SUBJECT: Crosswalk – 600 block New Hampshire

SUBJECT: Pedestrian Crosswalk, 600 Block, New Hampshire

Re: Pedestrian - Actuated Traffic Signal
600 Block of New Hampshire

MID-BLOCK < WEST → EAST - 65 > 153 = 77/HR
EAST → WEST - 88

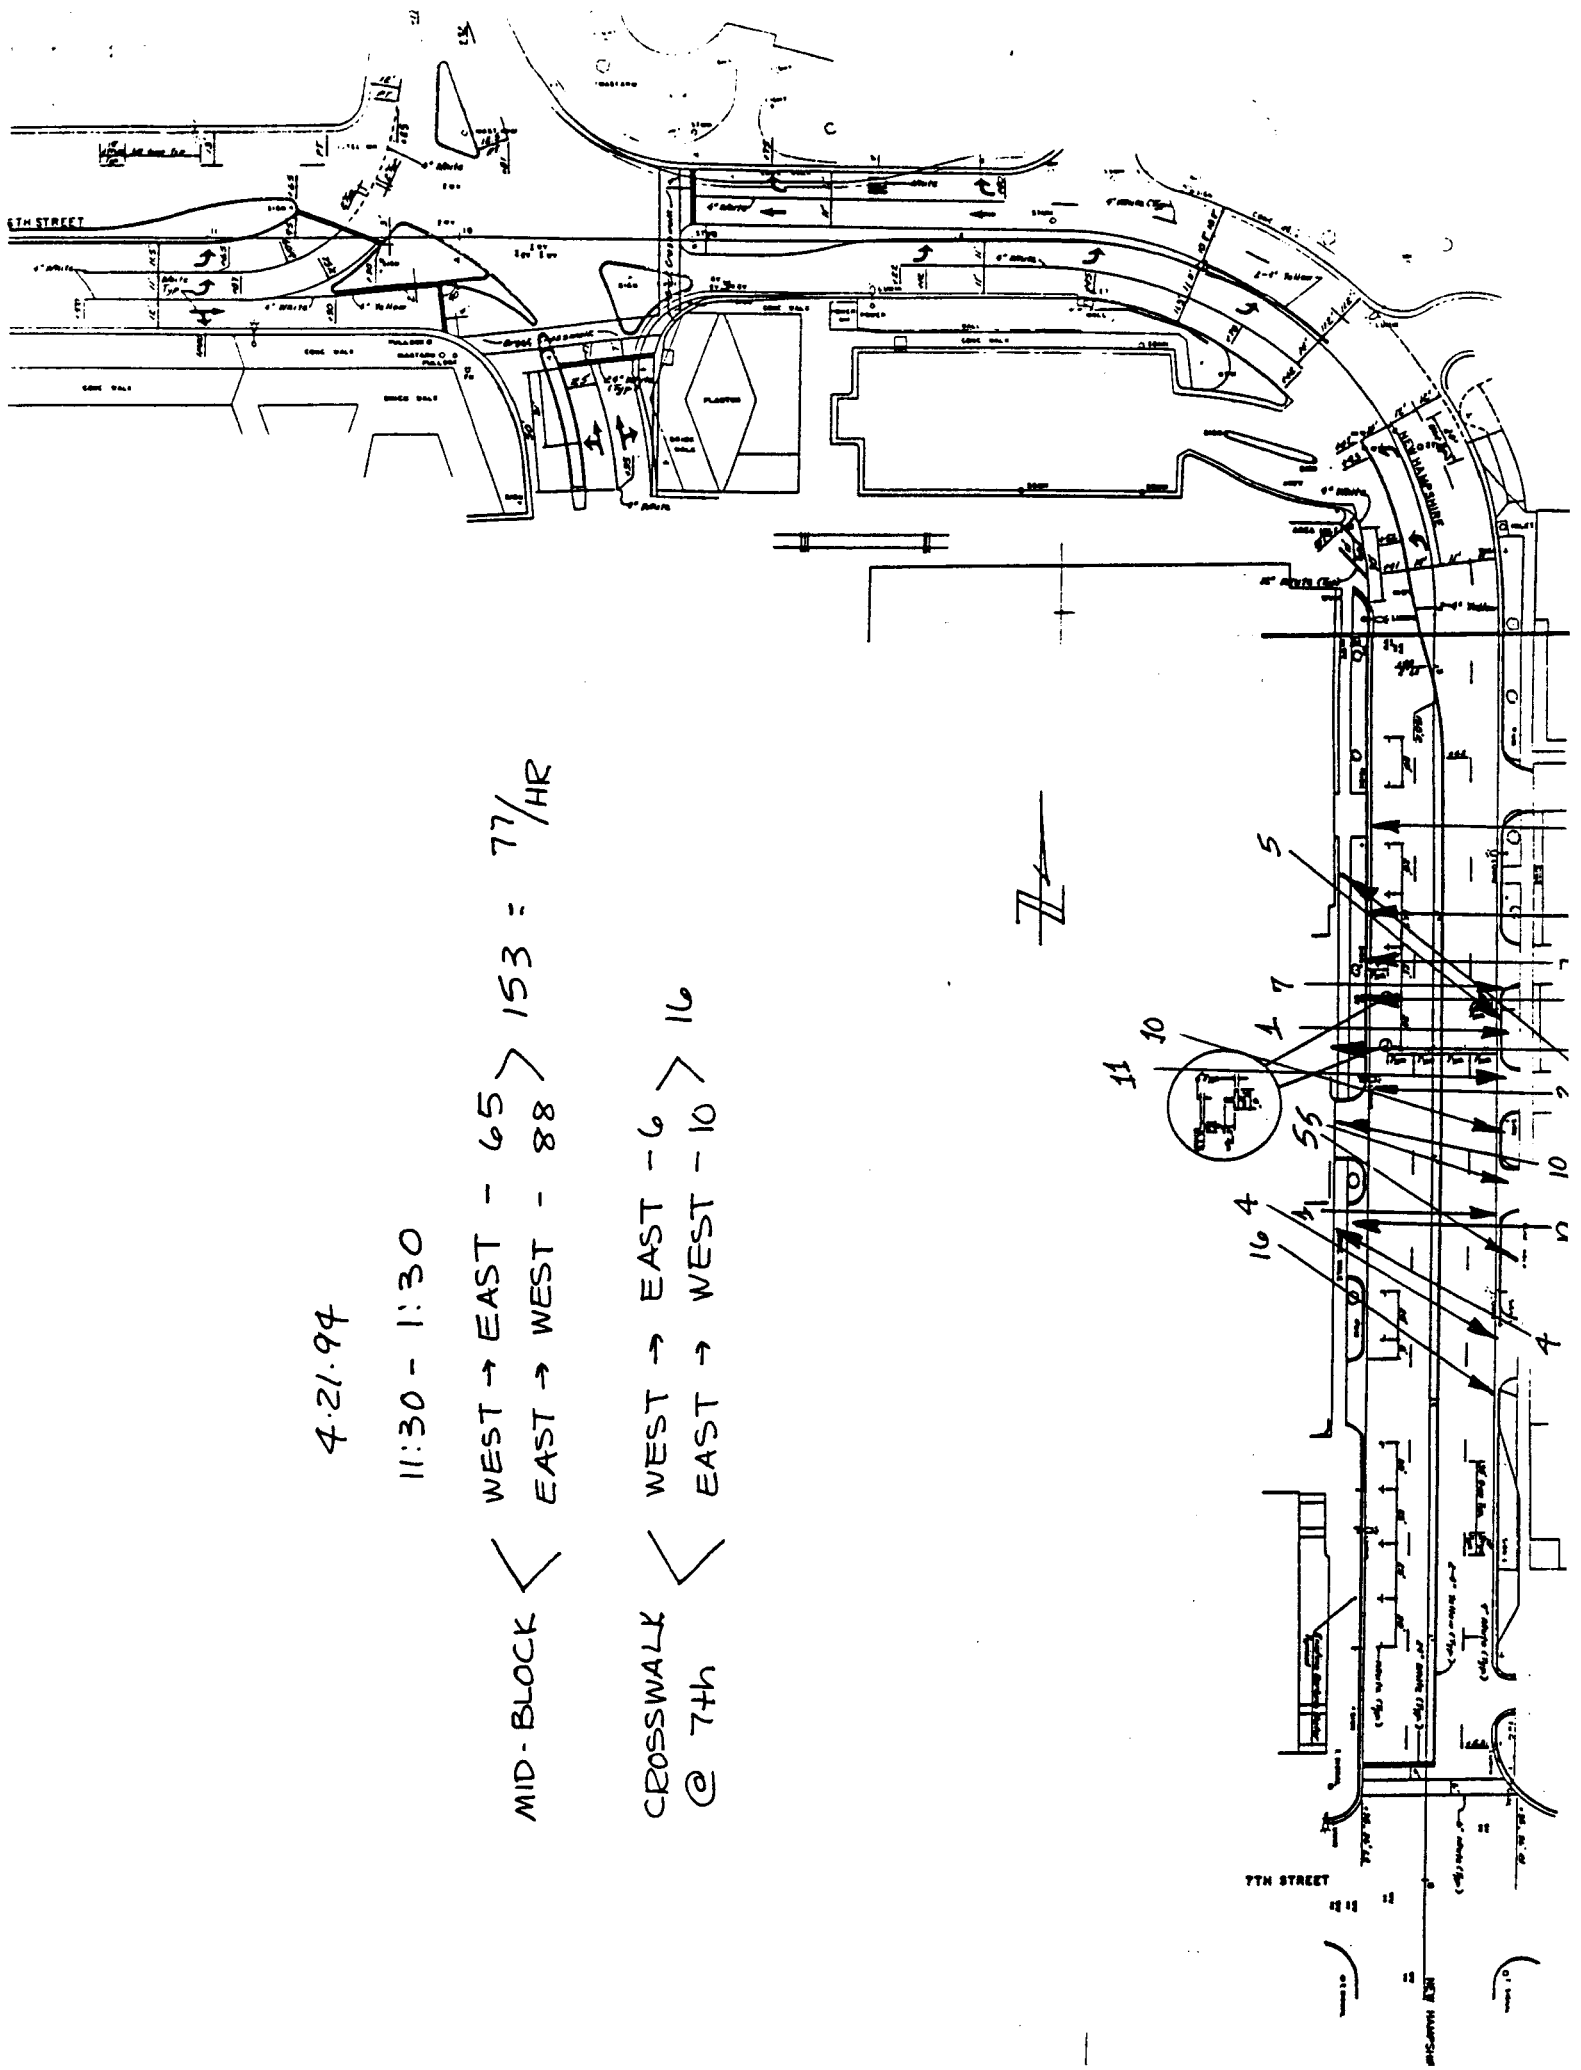
A mid-block non-signalized pedestrian crosswalk could be installed, however, based upon routes pedestrians are currently using (see attached sketch), it is questionable as to what percentage would actually use the crosswalk. A crosswalk of this type could be installed on a temporary basis, such as 90 days, with a compliance study conducted near the end of the trial period to determine whether to keep the crosswalk on a permanent basis or not. This would also require removal of the on-street parking spaces on the west side of New Hampshire Street in front of the Journal-World.

Site no. 2

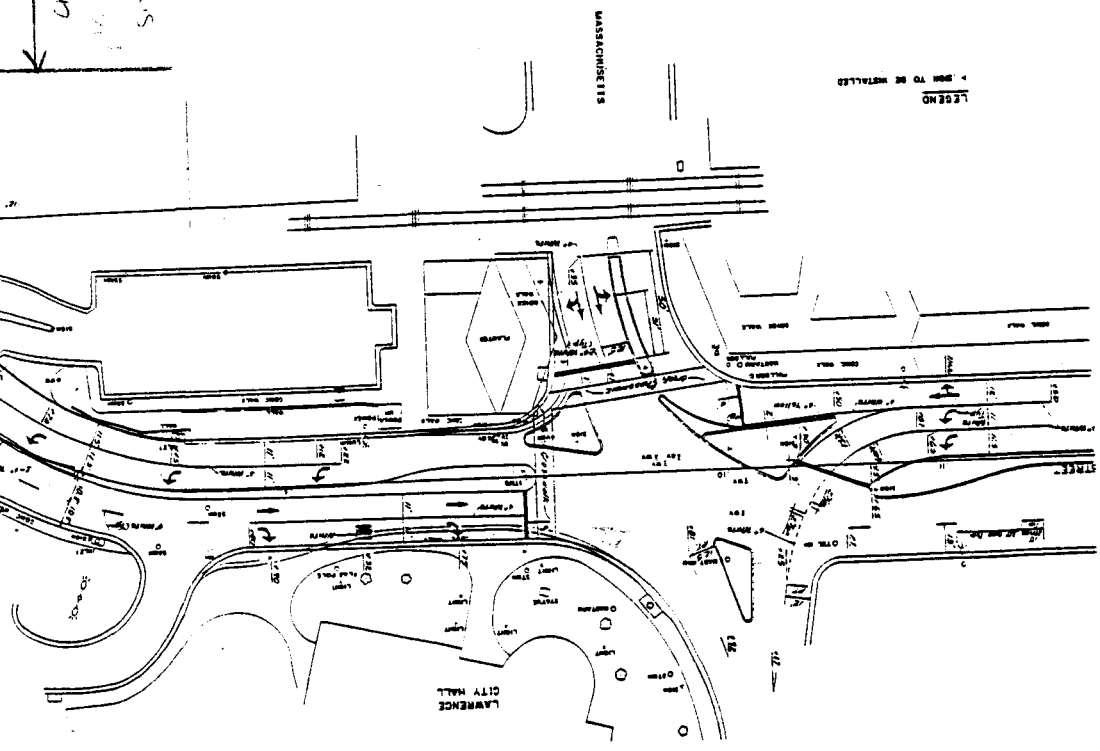
A pedestrian crosswalk (without a traffic signal) should be located at Site No. 1. This location allows the best visibility for drivers to see pedestrians in the crosswalk. However, on-street parking should be prohibited for 100 feet in advance of and 20 feet beyond the crosswalk in order to provide adequate sight distance.

A crosswalk at Site No. 2 does not provide adequate sight distance for eastbound drivers due to its location on the curve. This location also experiences a considerable volume of turning movements because of its proximity to the parking garage, the mall, and the city parking lot.

In regard to this segment of New Hampshire, the crosswalk that you identified as site no. 1 appears to be the only feasible location for a mid-block traffic signal between the 6th and Massachusetts and 7th and New Hampshire intersections. The crosswalk identified as site no. 2 is too close to the considerable turning activity at the adjacent driveways, would not afford

adequate visibility for eastbound drivers and would likely result in queuing on New Hampshire across the driveways serving the public parking lot and the outlet mall.
